State Water Resources Control Board

March 21, 2022

MADERA GROUNDWATER SUSTAINABILITY PLANS, GROUNDWATER SUBBASIN NO. 5-022.06

Figure 1. 1,2,3-Trichloropropane in Madera Subbasin wells

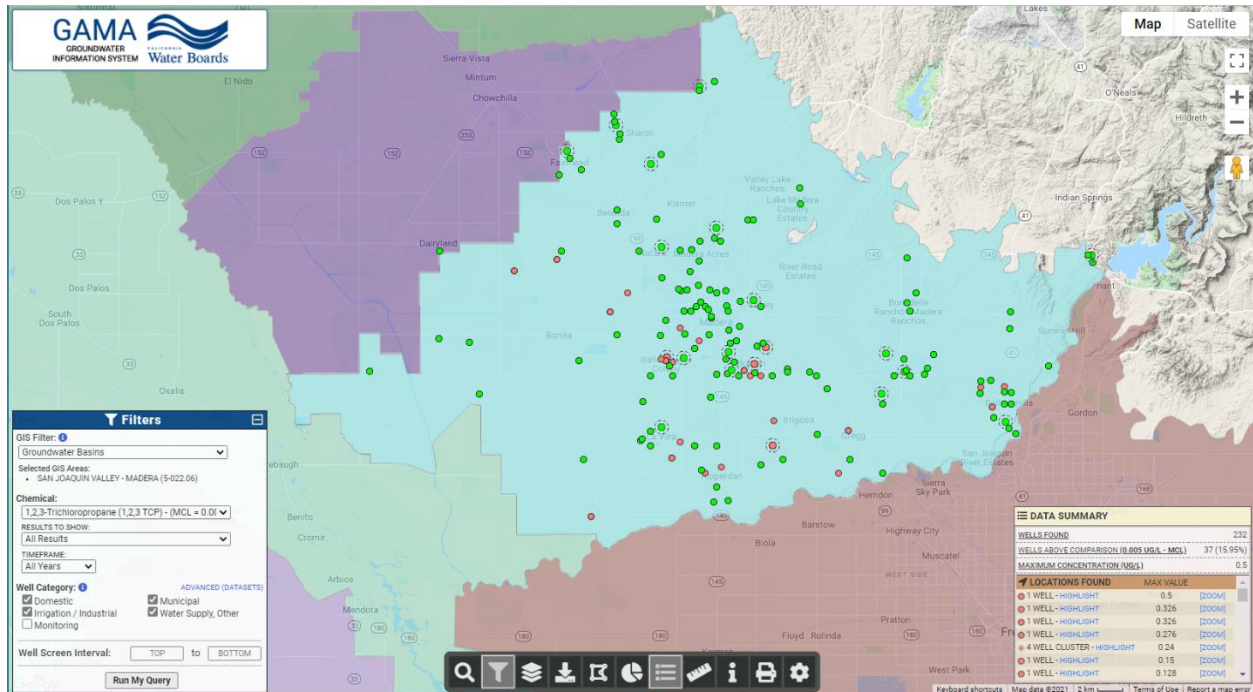
subbasin, including total dissolved solids (TDS), arsenic, nitrate, uranium, DBCP, and 1,2,3-TCP, as shown in Figures 1 through 6 (in Appendix); however, the GSPs do not share a consistent set of analyte MTs (see Table 1 below). Groundwater pumping and projects and management actions under the GSAs' authority may have the potential to influence groundwater concentrations and distributions of widespread contaminants within the subbasin, including these.

- a. *DBCP and 1,2,3-TCP.* DBCP and 1,2,3-TCP have been detected in groundwater at concentrations above MCLs in the northern-central to southern area of the subbasin. Both are legacy contaminants caused by applications of fumigant pesticides before the early 1980s, but are persistent and have migrated downwards through irrigation recharge and groundwater pumping. The state's Groundwater Ambient Monitoring and Assessment (GAMA) Program's Priority Basin Project shows that approximately 29 percent of the shallow groundwater resources (by volume) used for domestic drinking water in the Madera and Chowchilla subbasins have MCL exceedances in fumigant chemicals (DBCP, EDB and 1,2,3-TCP).⁶ In addition, the GAMA Program's online database shows the California MCLs for DBCP and 1,2,3-TCP were exceeded in eight and 20 municipal wells, respectively, between 2010 and 2019 in the subbasin.⁷

Staff recommends the GSAs coordinate to define undesirable results consistently for the subbasin, manage for the same set of constituents in SMC, and have coordinated monitoring well locations and sampling frequencies. Based on their prevalence within the subbasin, all of the GSPs should include, at minimum, SMC for TDS, arsenic, nitrate, uranium, dibromochloropropane (DBCP), and trichloropropane (1,2,3-TCP), or provide a rationale for why these constituents are not included. Additional information on the prevalence of DBCP, 1,2,3-TCP, and uranium are provided below.

Figure 5. Uranium in Madera Subbasin wells.

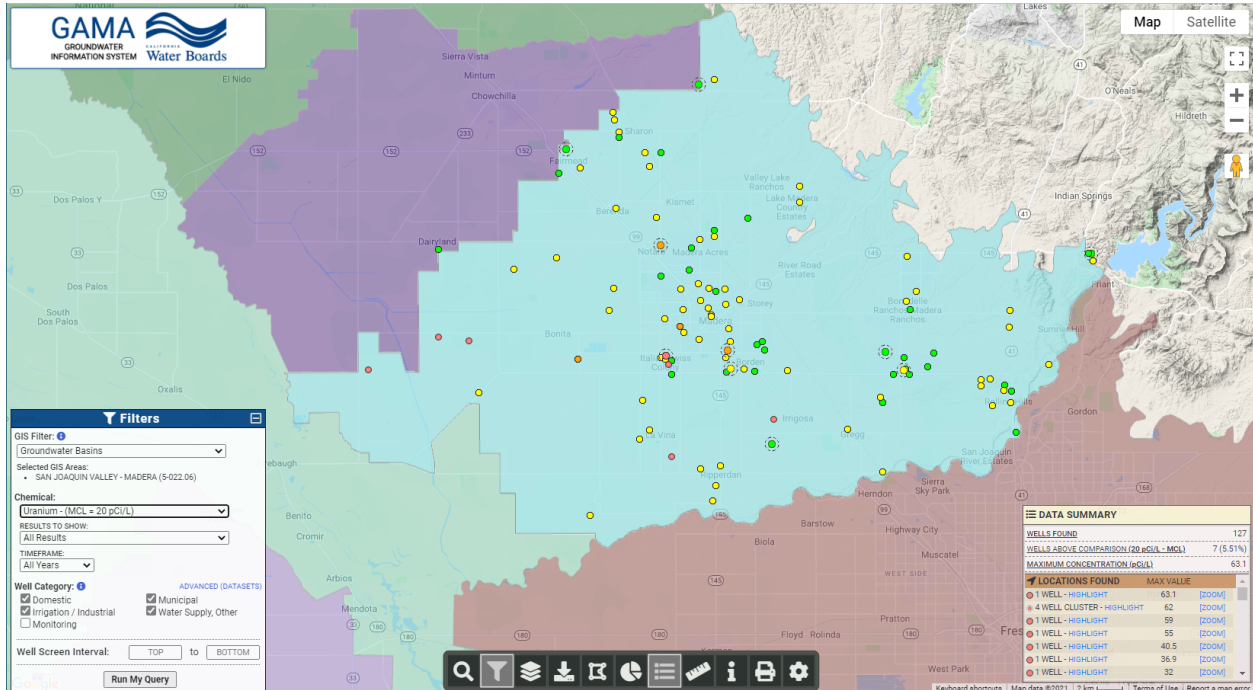
- b. *Uranium.* Uranium concentrations above MCLs (i.e., US EPA MCL of 30 micrograms per Liter [ug/L] and California MCL of 20 ug/L) have been found in shallower wells (depth to top of well perforations less than 235 feet) in Chowchilla-Madera.⁸ Elevated uranium concentrations in groundwater in the eastern San Joaquin Valley are likely caused by uranium leaching of shallow sediments by irrigation water enriched with bicarbonate in the root zone and
